Dimension Change for CLMXB-FKA LEDs

PCN-CM093

Announcement Date: November 30, 2016

Current Dimensions

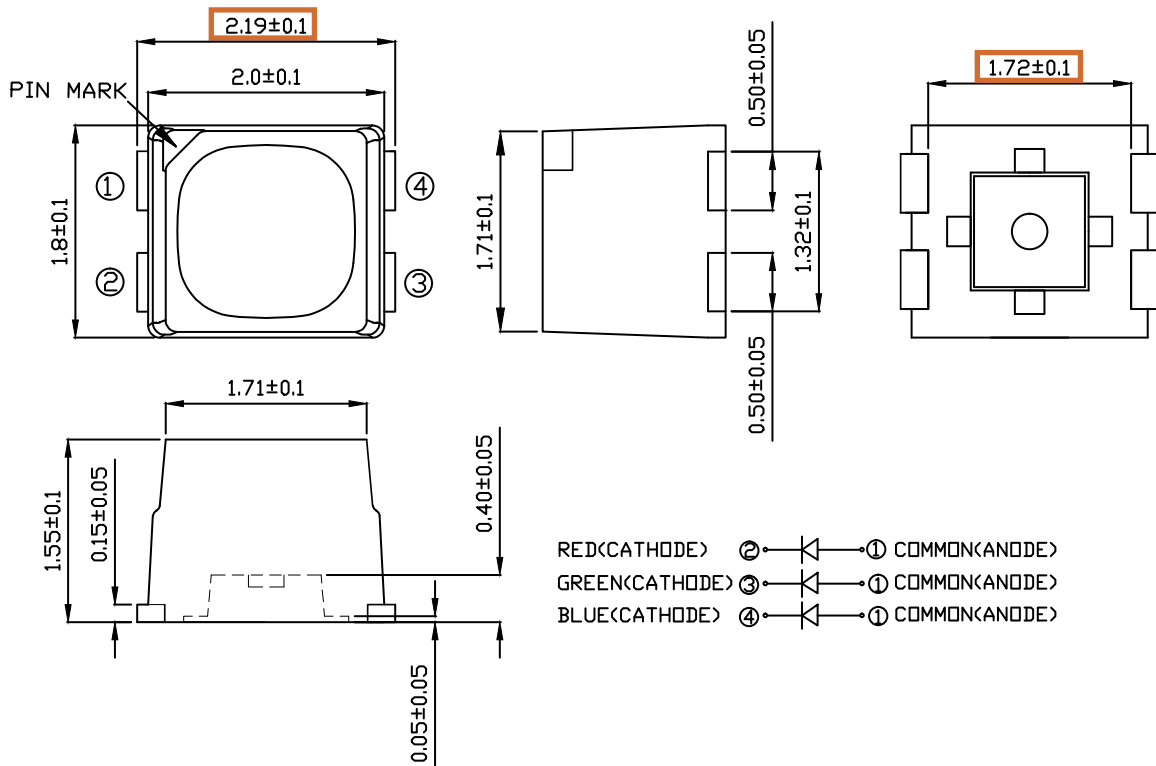
Cree will begin shipment of CLMXB-FKA LEDs with new dimensions. Diagrams showing the current and new LED dimensions are shown below. (Orange boxes outline the affected dimensions.) Cree has analyzed the optical, electrical and thermal properties of the LEDs made with the new dimensions and found them to be identical to the data sheet specifications of the LEDs made with the current dimensions. Please refer to the latest data sheets on www.cree.com.

For the best screen appearance, Cree recommends against mixing new dimension LEDs with current dimension LEDs in the same display. For more information concerning this recommendation, please contact your local Cree sales representative.
